WORTHINGWAY MIDDLE SCHOOL

August 15, 2011

**Re: Construction Storm Water Inspection at Worthingway Middle School  
Franklin County  
Permit Number: 4GC03537\*AG**

**Figure 1: Storm drain requires appropriate inlet protection**

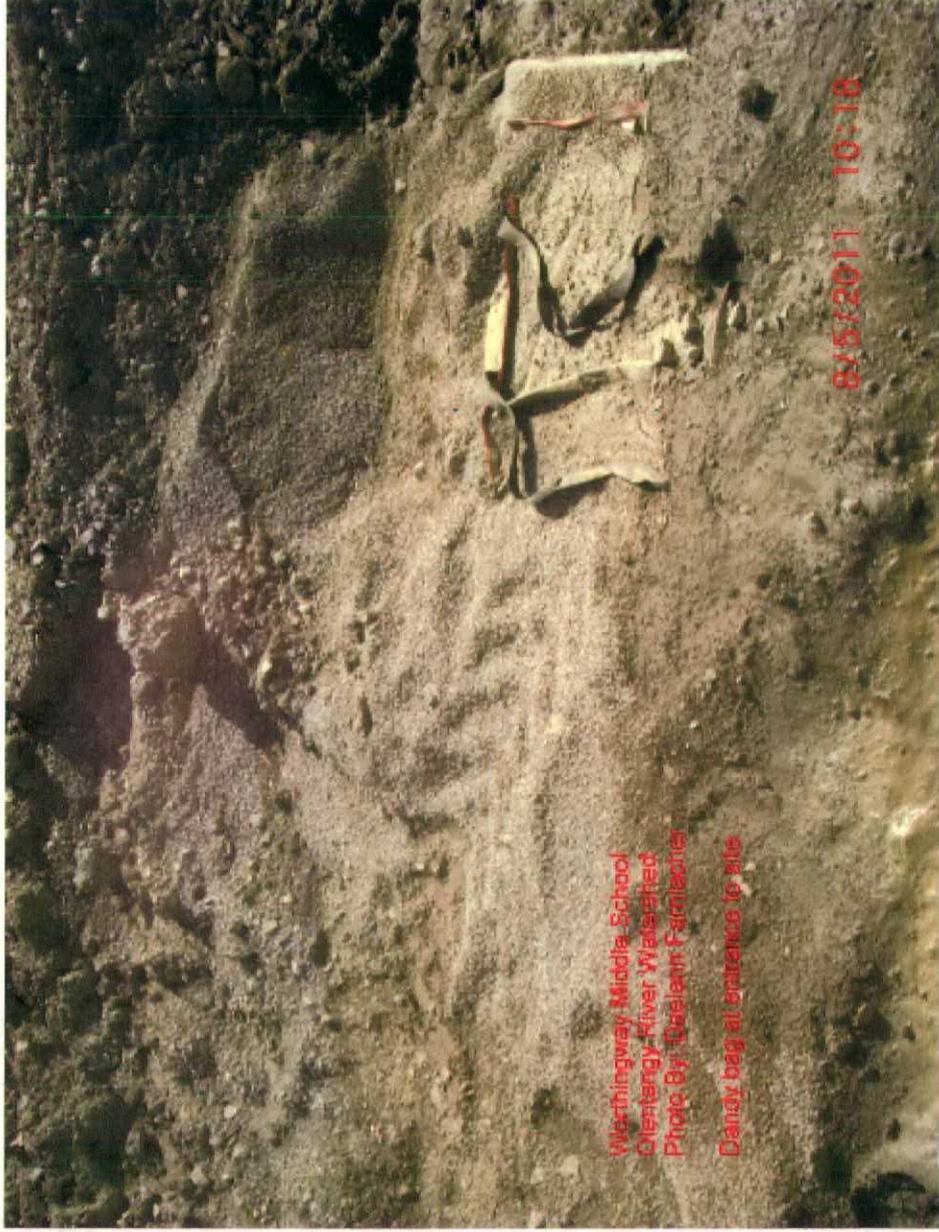
- Please maintain the clogged dandy bag located at the entrance to the site (see Figure 1).
- It appears the current excavation of the site contains all storm water. Please ensure all storm water remains contained as construction progresses.
- Be aware the General Permit states that all barren areas which remain idle in excess of 21 days must be protected from erosion within seven days of the last earth disturbing activities. In addition, erosion protection must be implemented for all areas of final grade within seven (7) days.
